Architectural Review and
Historic Preservation Board
Agenda Report

File: AR 21-21

RE: Architectural Review 21-21 (Tank District) – Lot 301 Tank District, Meriam Park
Subdivision S 09-01, (APN 002-690-019)

RR - ENLARGED SITE PLAN
SCALE: 1" = 10'-0"

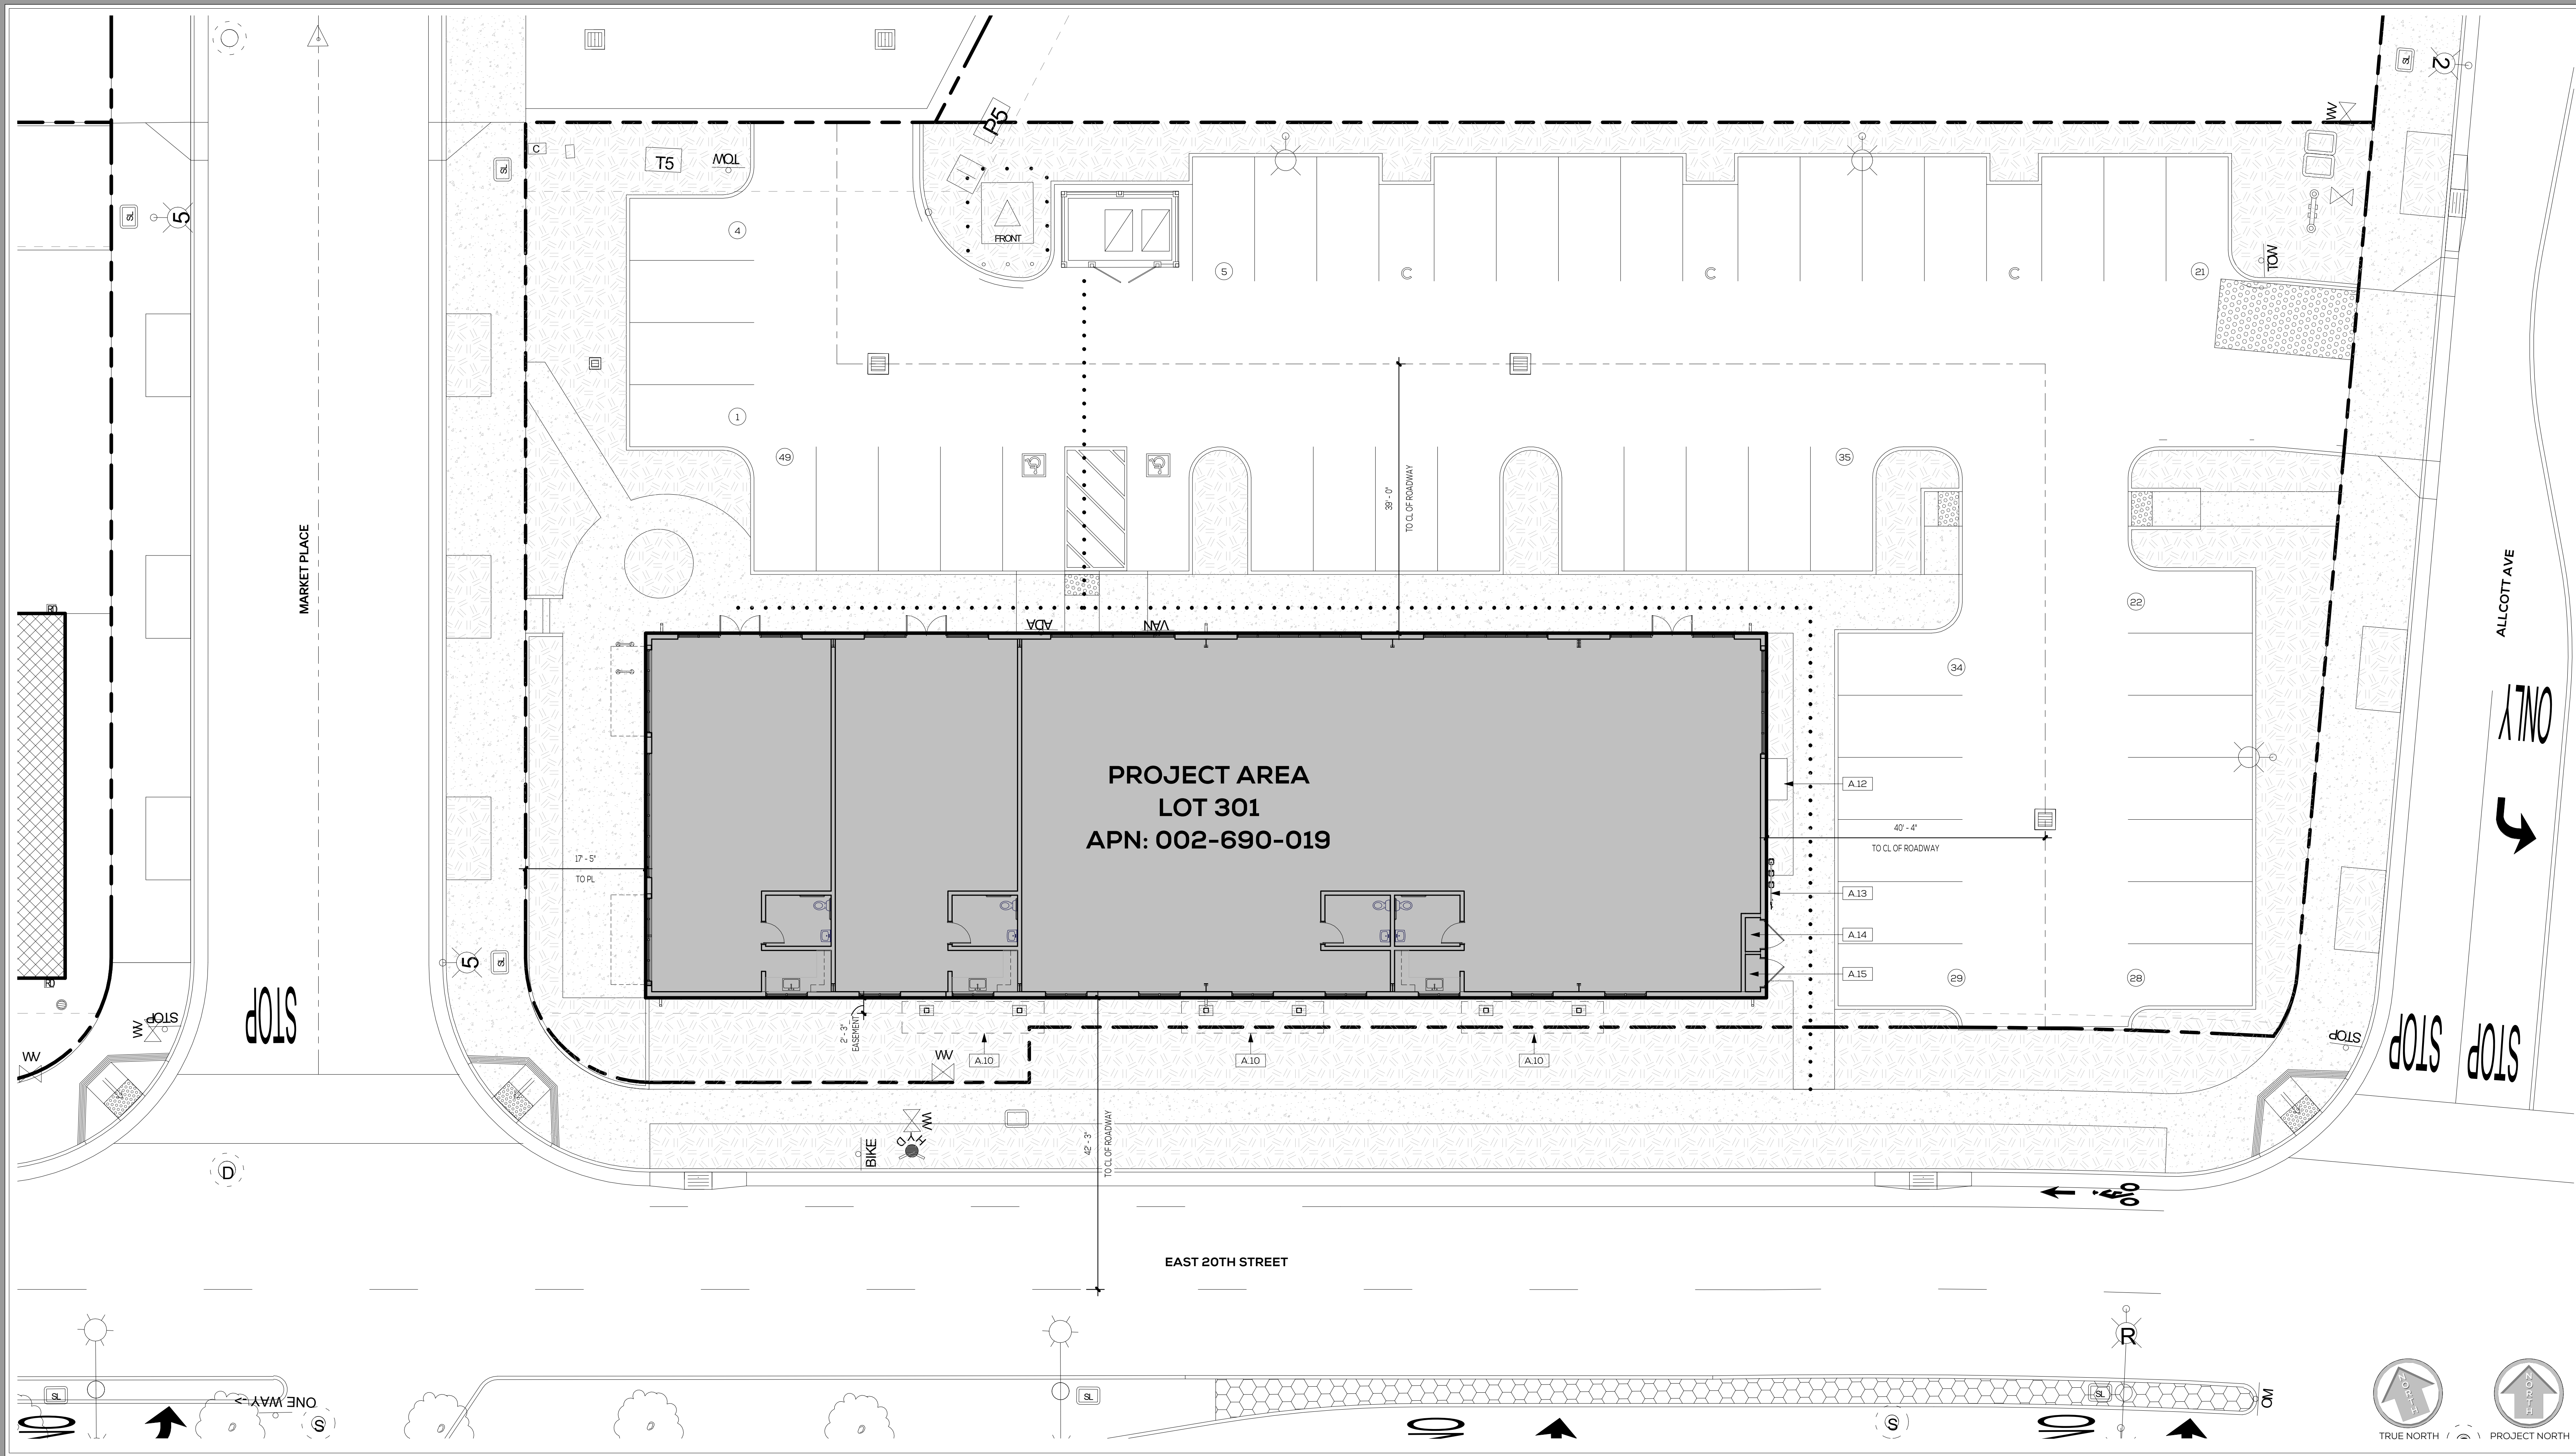
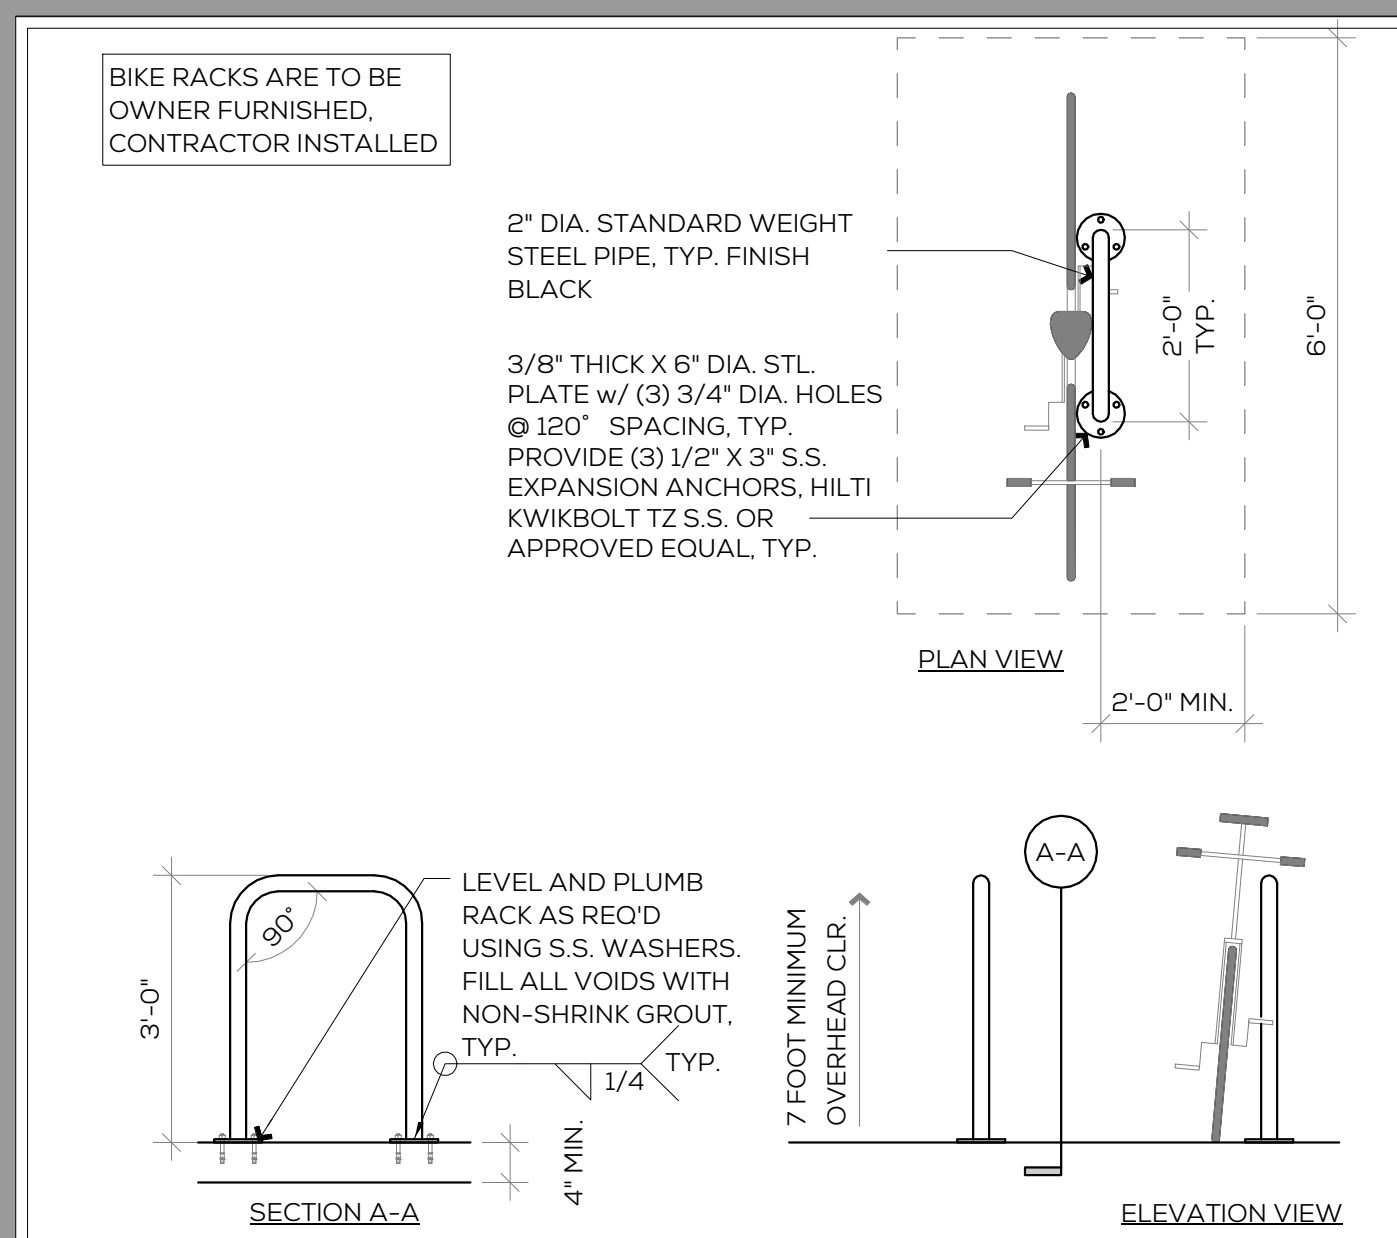
4. Eliminate the two parking spaces nearest East 20th Street to provide a minimum 20-foot landscaped setback between the parking area and the back of public sidewalk along East 20th. The parking area shall be screened by mounding up the

landscaped setback area to a minimum height of three feet above the parking lot surface, by installing a solid masonry wall at least three feet in height, or by installing a decorative metal picket fence with climbing vines planted along the base.
